# TECHNICAL BULLETIN

Range Rover  
Discovery Series II  
Defender

Bulletin N<sup>o</sup>: 0018  
CDS. ref: L8635bu  
Issue: 1  
Date: 09.05.01

### OIL LEAK FROM GEARBOX - FRONT COVER

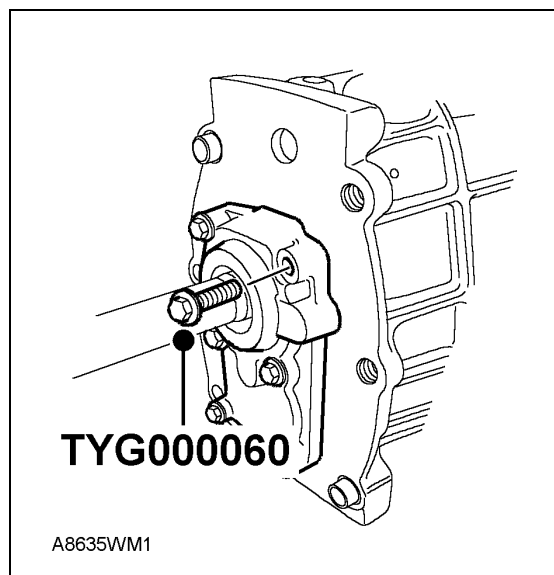
An oil leak path can develop along the threads of the front cover securing bolts.

At the following VINs, new front cover securing bolts incorporating a thread sealant were introduced:

The new bolts, part number TYG000060, are now available from Land Rover Parts and should be used during all R380 gearbox repairs where the front cover is disturbed.

- Ensure that all mating faces are cleaned and degreased.
- If necessary, replace the input shaft oil seal.
- Apply sealant STC4404 (Marston 607), originally introduced on Technical Bulletin  0013.
- Tighten bolts to a torque of 25Nm in a diagonal sequence.
